CITY OF KIRKLAND
Planning and Building Department
123 Fifth Avenue, Kirkland, WA 98033
425.587.3600 ~ www.kirklandwa.gov

MEMORANDUM

To: Design Review Board
From: Aoife Blake, Associate Planner
Date: October 21, 2020
File No.: DRV20-00187
Subject: **108TH OFFICE PROJECT
DESIGN RESPONSE CONFERENCE**

CONCEPTUAL DESIGN CONFERENCE

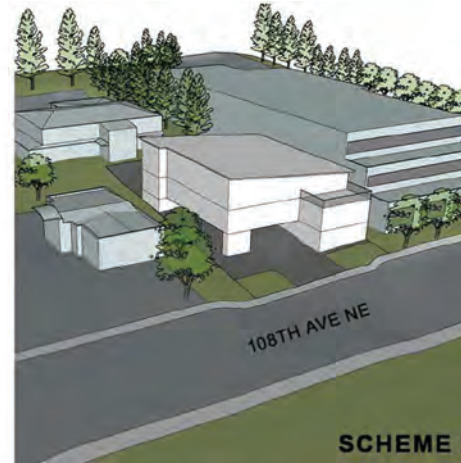
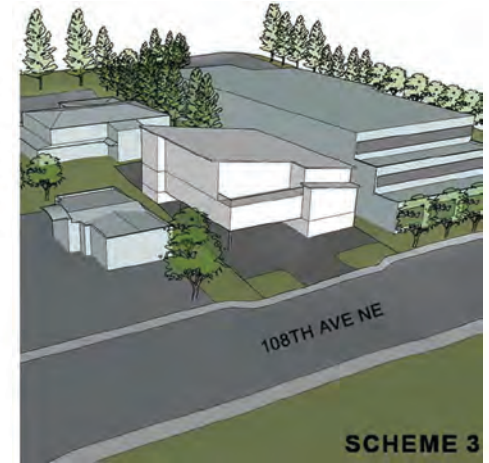
The DRB expressed a preference for either Scheme 2 or Scheme 3 (the applicant's preferred plan) at the Conceptual Design Conference. Other design direction provided by the DRB included creating a strong street presence with a prominent entry-way form.

The building has evolved since the previous meeting and now incorporates a main entry element on the south west corner of the property. This mass also serves as the rooftop mechanical screen. Instead of having the entire entry element project beyond the front façade as was previously designed, the second floor façade continues all the way across the front elevation in order to meet the required 5' minimum upper level setback. The north portion of the façade steps back further in order to meet the required 15' average setback and provide a rooftop deck for tenant use.

LANDSCAPE SITE AND PLANTING PLAN
1" = 20'-0"

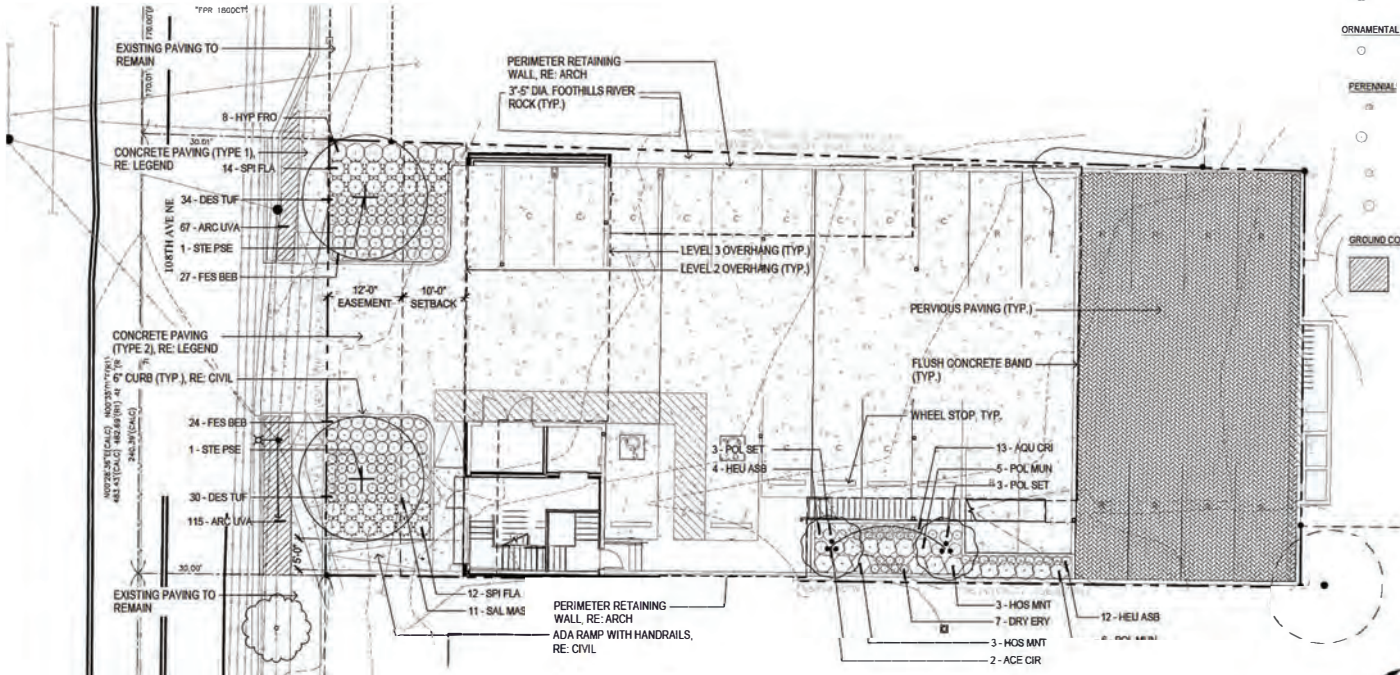
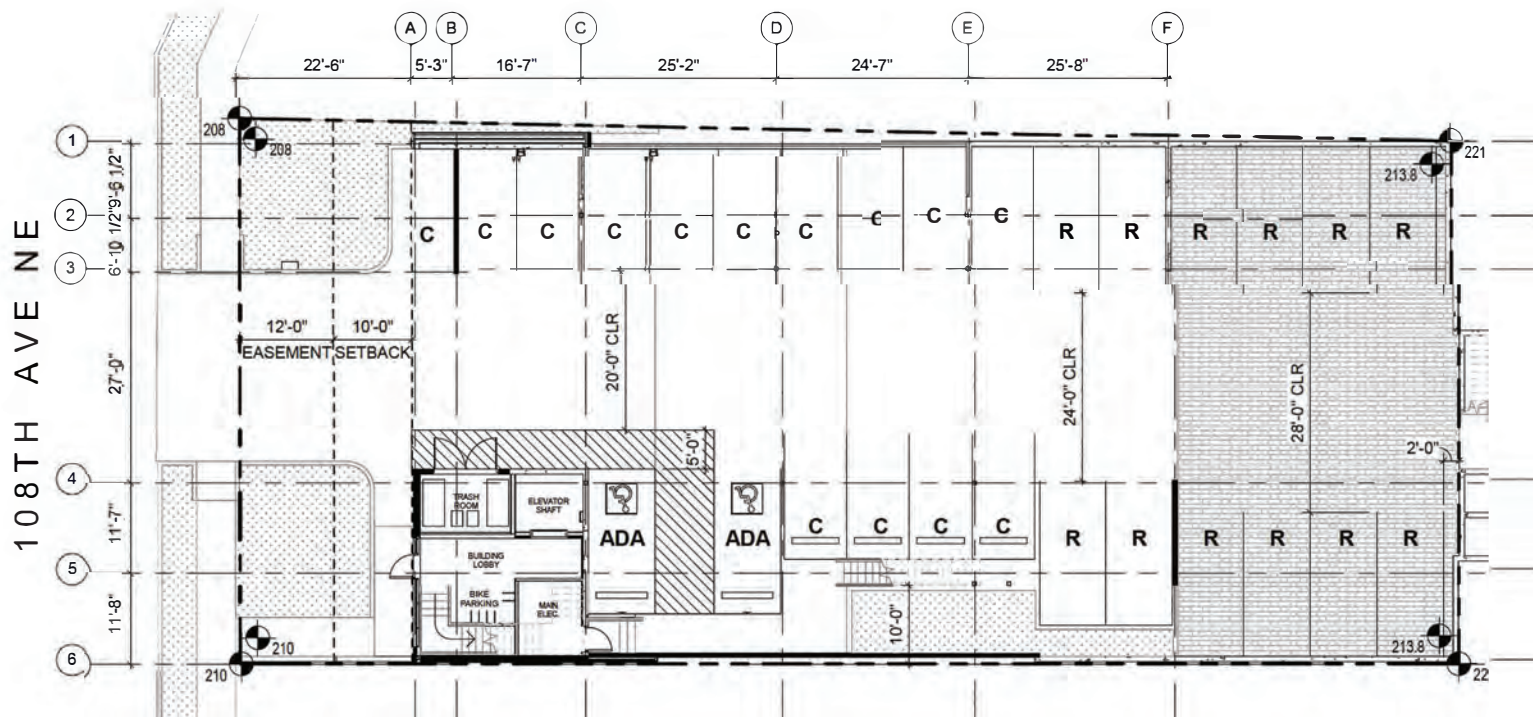
The applicant submitted a conceptual landscape plan and species list (see Attachment 2, page 13-14). Landscaping should be placed in areas to help mitigate building massing and enhance the pedestrian experience along the project frontages.

- *What changes are needed to the landscape plan?*
- *Are there other opportunities for landscaping?*
